RE: Health Department Information
needed for approval of site
for a buildable lot near Guil-
ford Rd. and Oakland Mills Rd.

Perc Certification
Harry Knisley Property
Route 32

STATE OF MARYLAND - DEPARTMENT OF HEALTH AND MENTAL HYGIENE

KNISLEY PROPERTY
LOTS 1 & 2

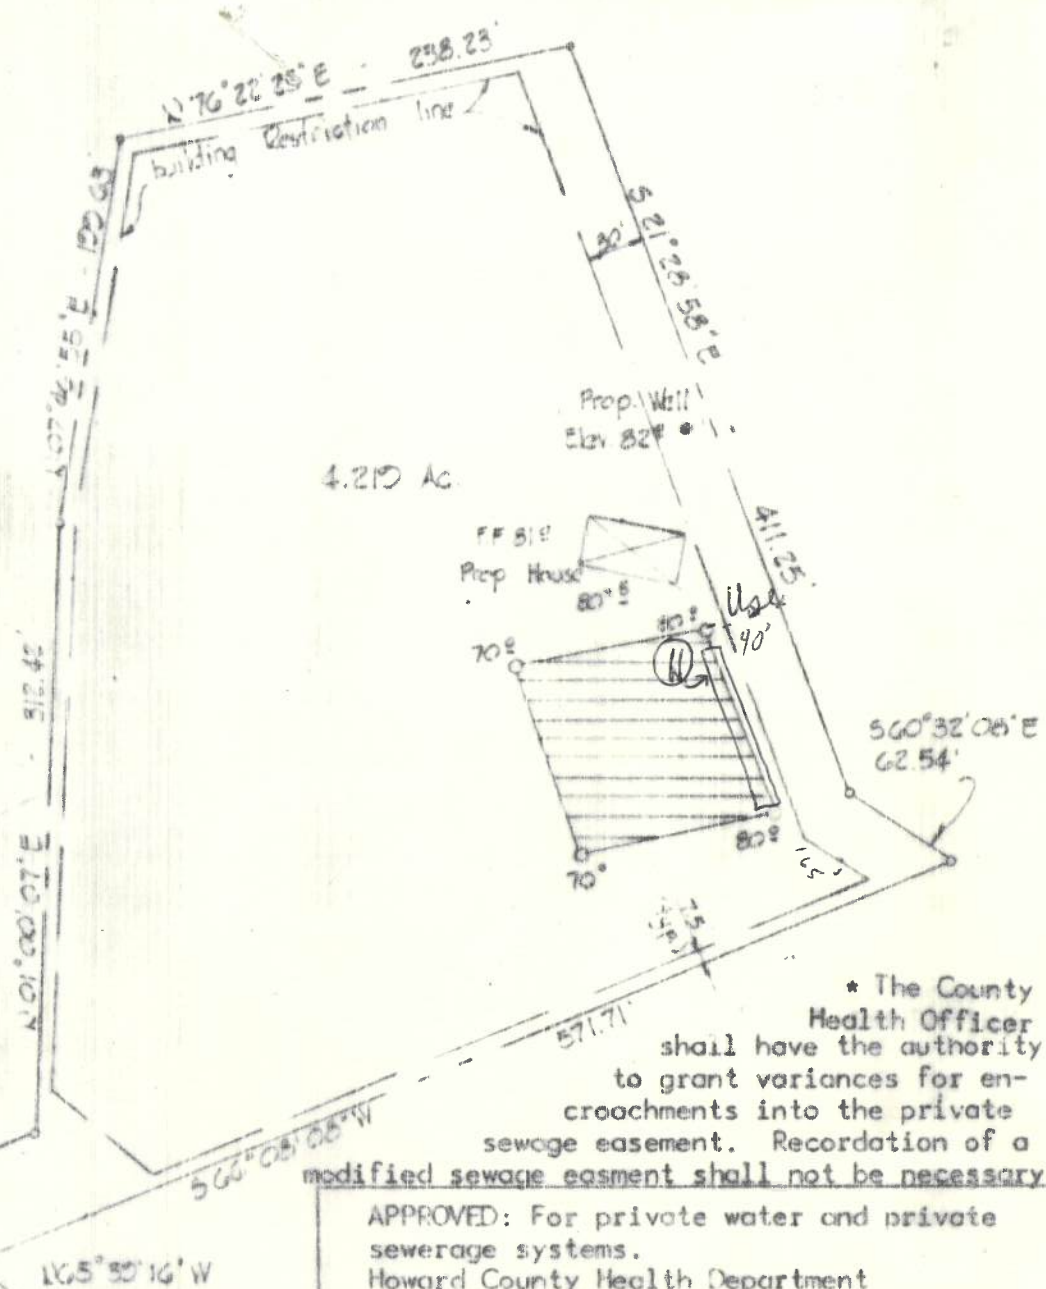
4/27/81 11:39
Called
T. Pittman
property - plat
ok & signed
C.B.

Trenches to be 2' wide. Inlet to be 4' below original grade and effective absorbant area from 4' - 8' only. Maximum depth of trenches to be 8' below original grade. A minimum of 175' sq.ft. effective absorbant sidewall area per bedroom needed. Trenches can not exceed 100' in length. Distribution box to be used if more than 1 trench used. Two inspections of trenches required - before and after stone installed. If more than 1 trench used - need to have 15 ft. distance between trenches, center to center. Run trenches on contour.

(DUE TO ELEVATION DROP!! IN SEWAGE DISPOSAL AREA)

LOCATION: Start trenches at a point 40' from line being S 21° 28' 58" E and 411±' in length and 115' in from line being S 66° 08' 08" W and 577±' in length. when facing lot from MO. RT. 32

TITLE:
 Perc Certification
 Harry Krisley Property
 Route 32
 4th Election District Howard County, Maryland

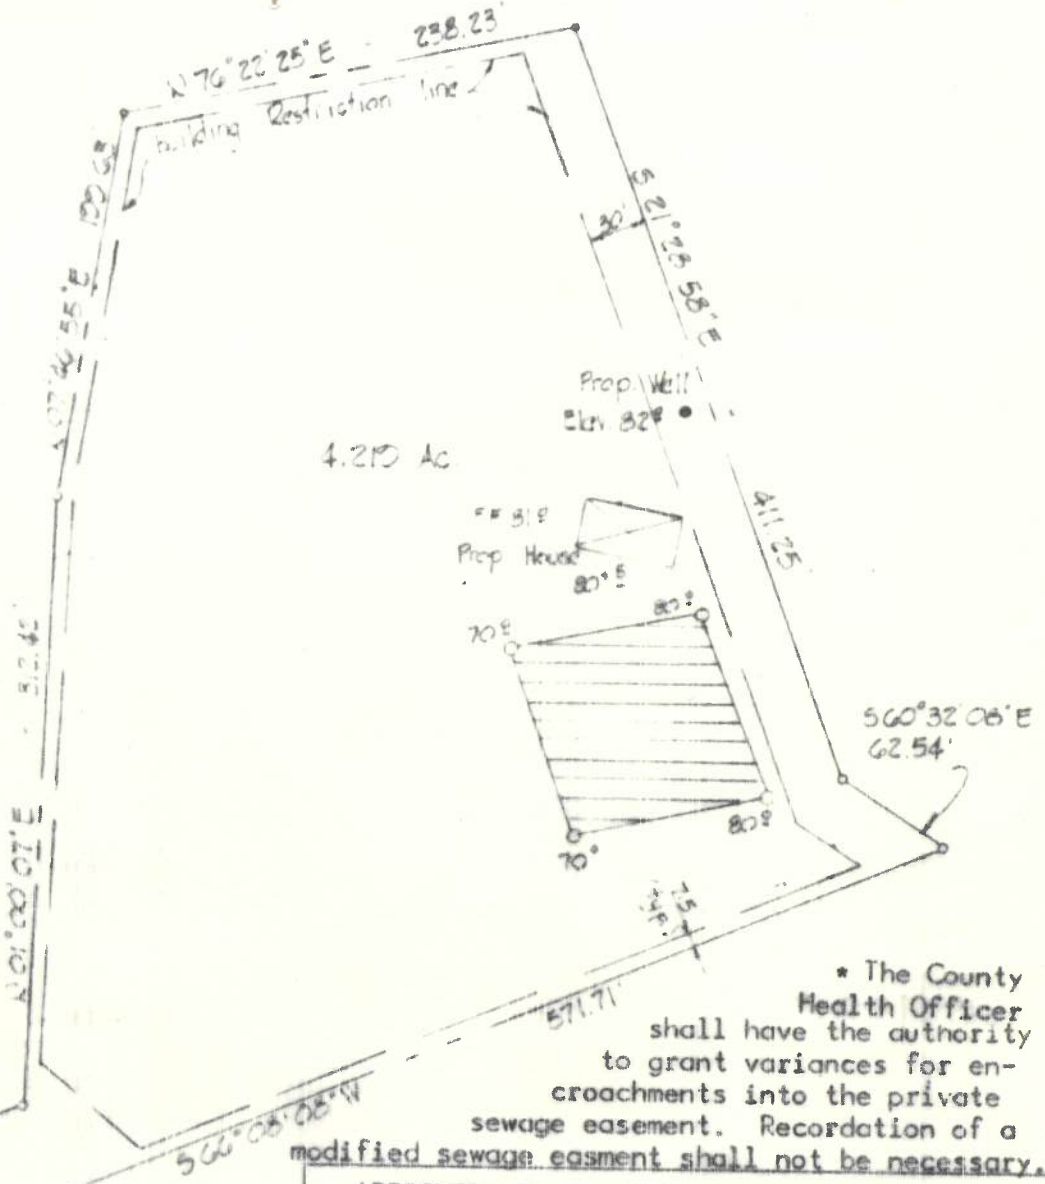
(1) Need to note restricted
house site on lot + show
house + well.

(2) Show tops also!! possibly
+ for ^{stake} elevation of house
site; well site, + perc. holes.

(3) all ink also 4/10/81!! C.B.D.

Corrected plat of
Harry Knisley Property
RT 32 ok as shown.
for signature.

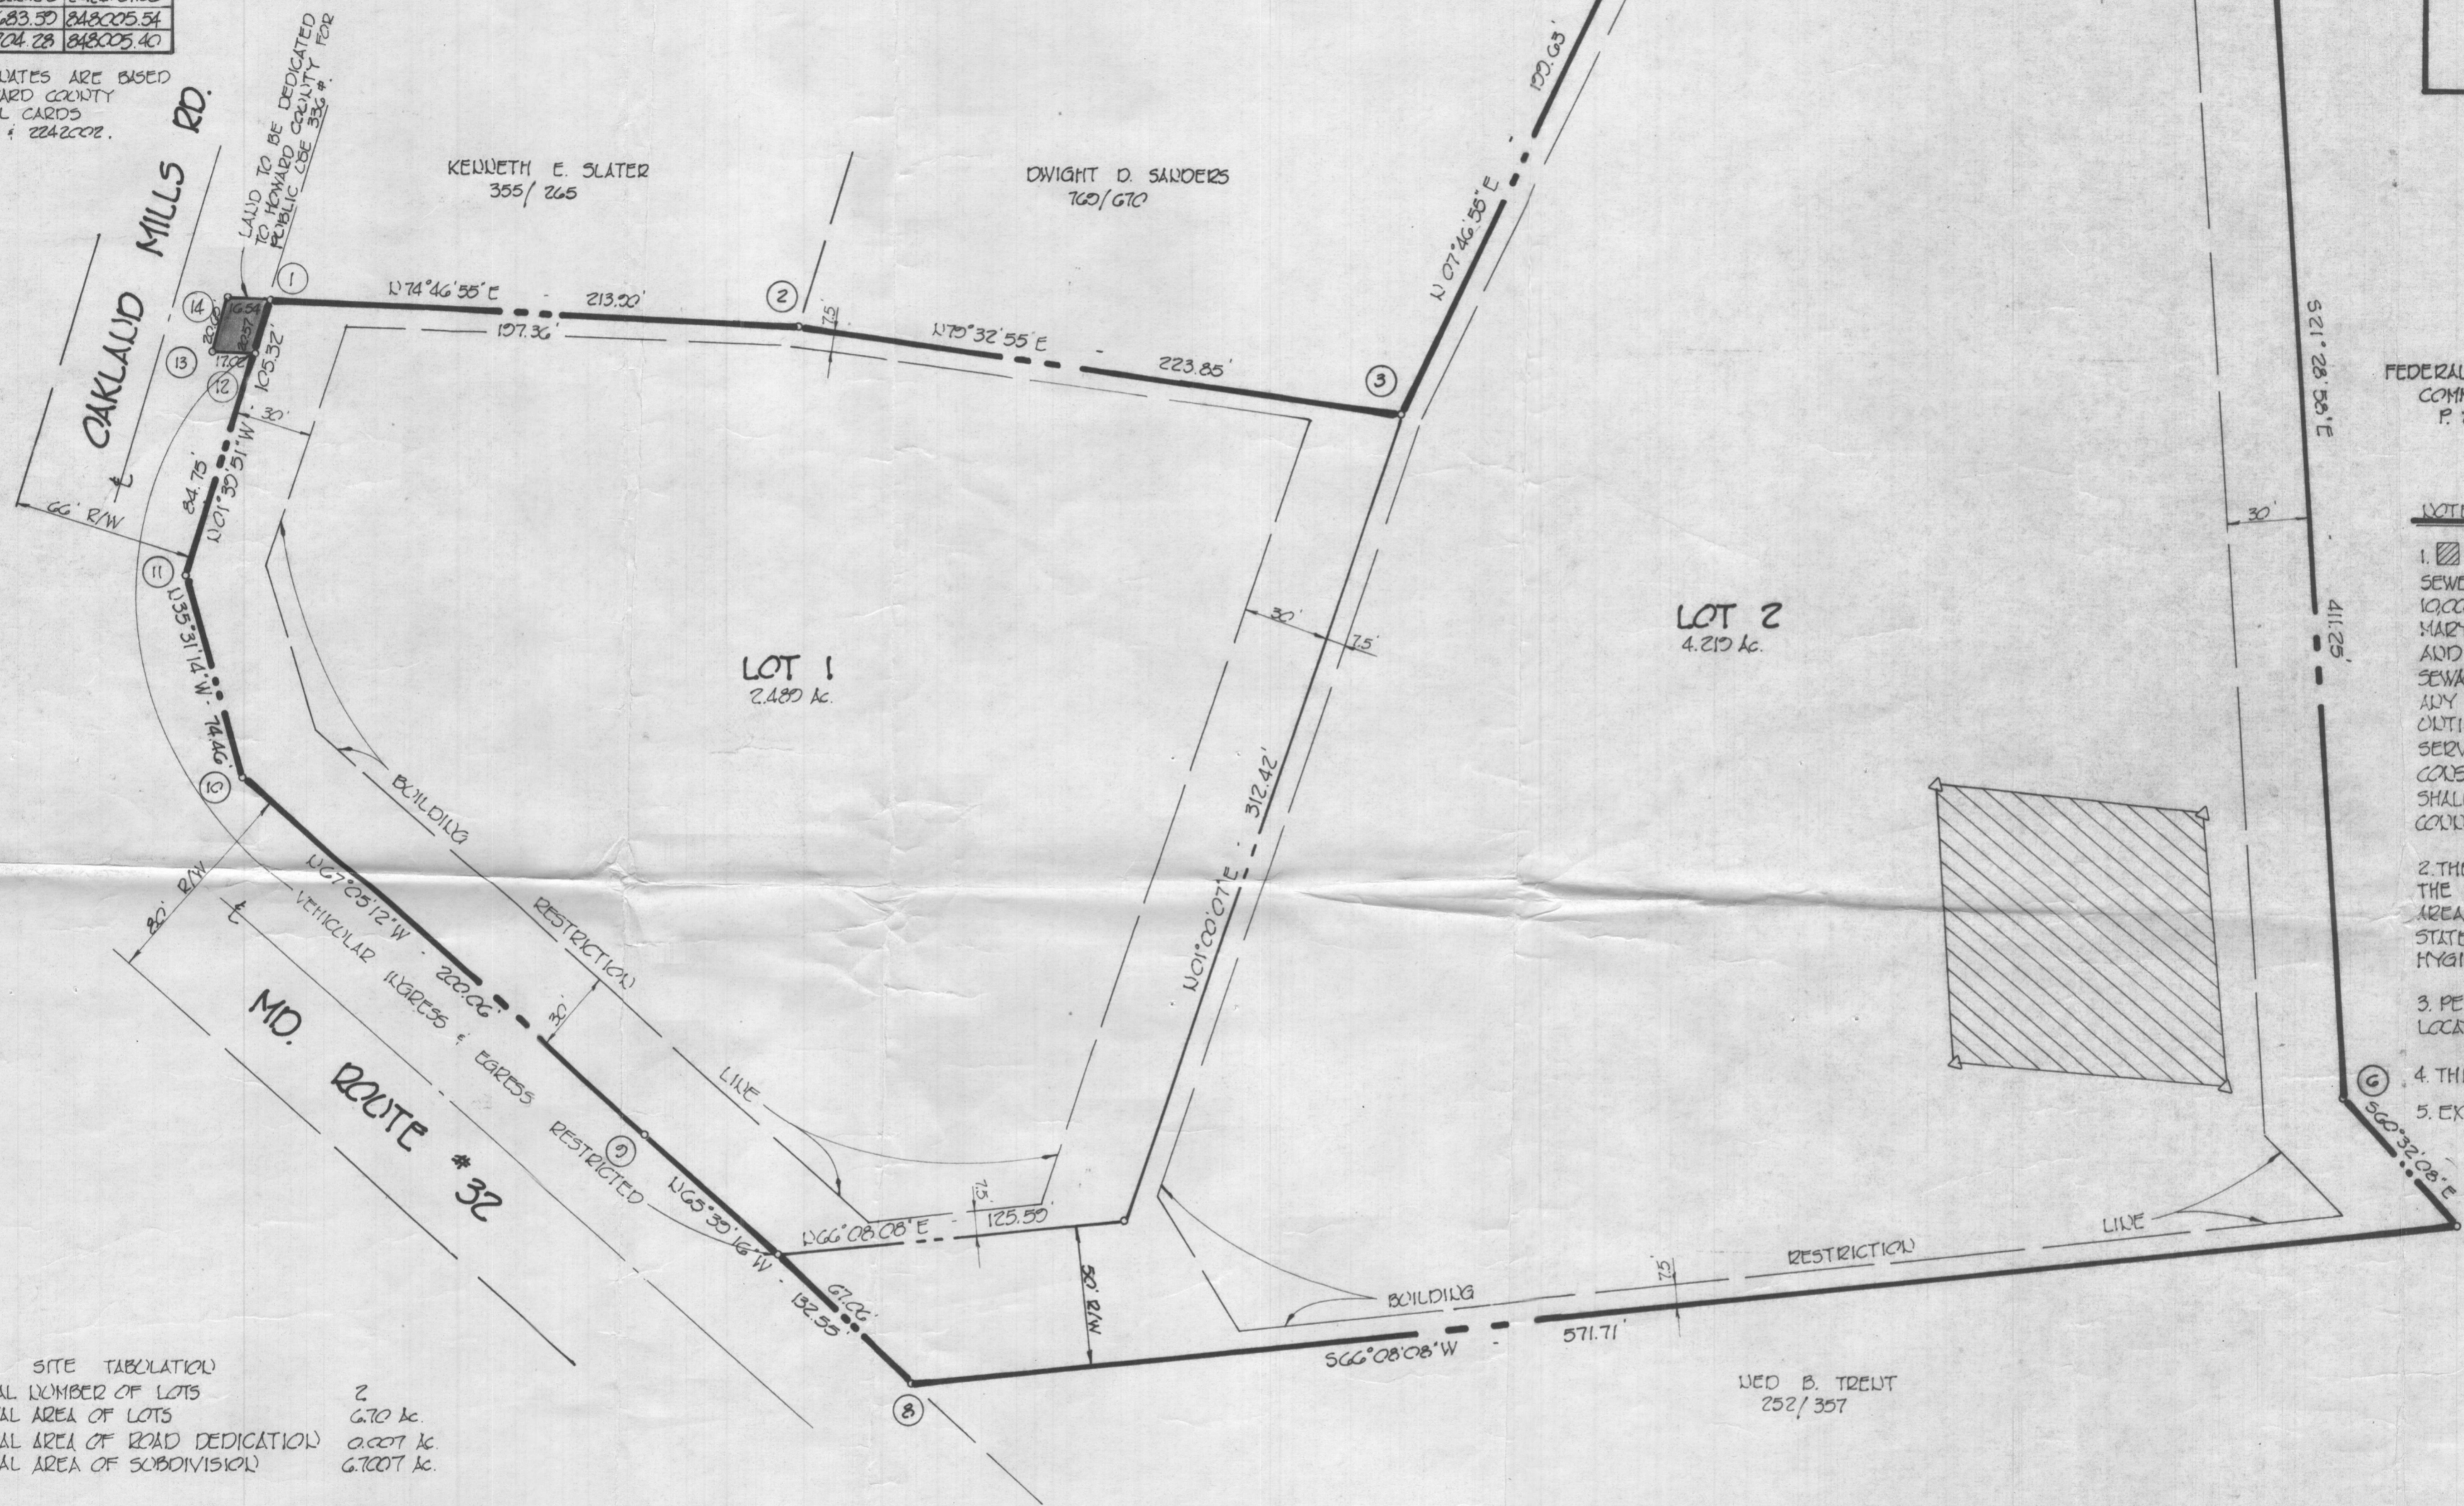
[6/25/81 F-81-140]
Harry Knisley property
ok. for approval
C. B. S.
